Memorandum

Date: February 12, 2020

Re: Yaakov Friedman, Shul in Existing Dwelling, 32 Blueberry Lane, Highland Mills
Tax Map ID#: 217-2-4.2

- Site Plan Review and Approval, Application for Public Hearing, signed by Yaakov Friedman, dated December 23, 2019.
- Sheet 1, Page 1 of 1, Site Plan for Yaakov Friedman, by Fusco Engineering and Surveying, P.C., stamped by Alfred A. Fusco, Jr., P.E., with latest revision date of 11/22/ 2019.

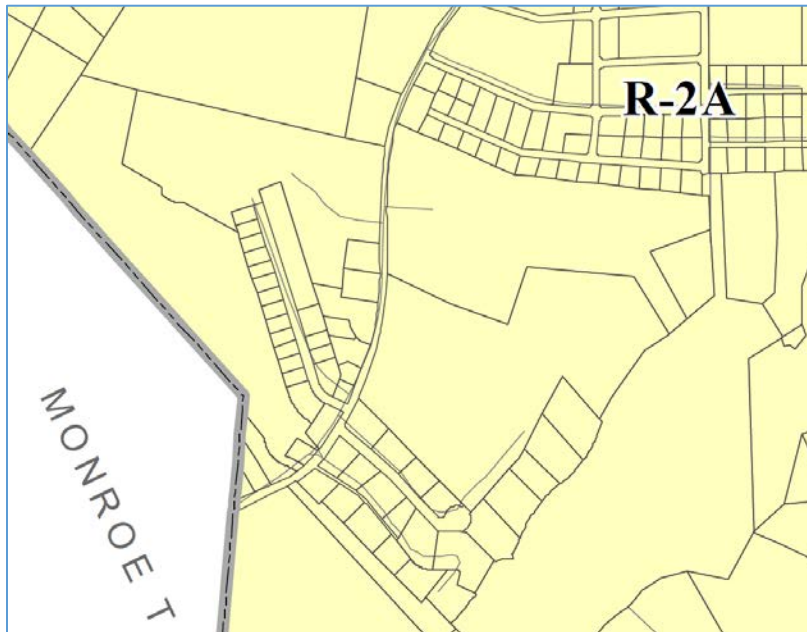
1. Places of worship are a permitted use by Special Permit and Site Plan Review of the Planning Board in R-2A. The Zoning Requirements Table on the Site Plan indicates the zoning district of the subject parcel as “R-3A.” This should be corrected to R-2A. A screenshot of the Zoning Map appears below:

2. The required bulk and area standards should also be corrected to reflect the requirements for a Place of Worship, as listed in the Special Permit Uses at row 1 of the §310-7 Schedule of Zoning District Regulations, R-2A District Table:

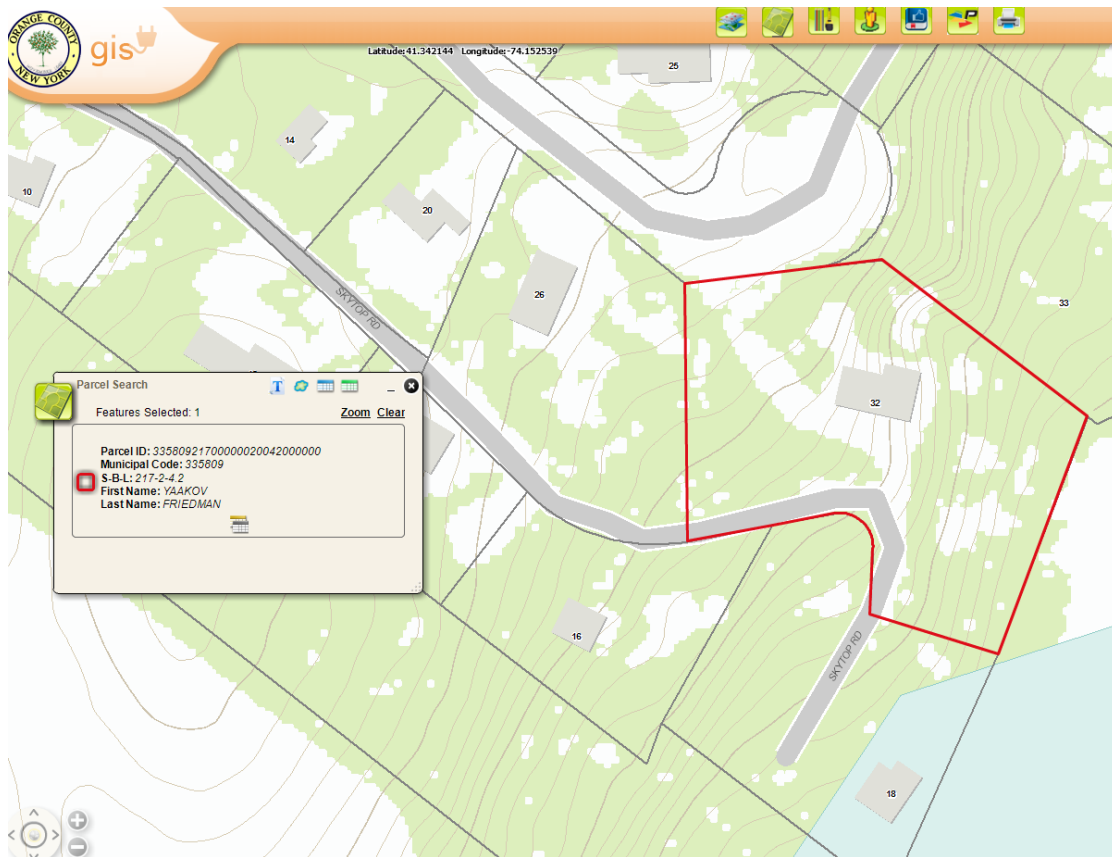
5. The south side of the subject lots appears to have street frontage on Skytop Drive. It appears that this portion of Skytop Drive is be privately owned and would require a 30-foot front yard (per discussion with Building Inspector, see Tax Map below). Therefore, this lot would be considered a “double frontage” lot, with two front lines and two front yards. Parking is not allowed in a front yard, and proposed spaces are shown approximately 3 feet from the edge of the 16.5 foot-wide right-of-way.
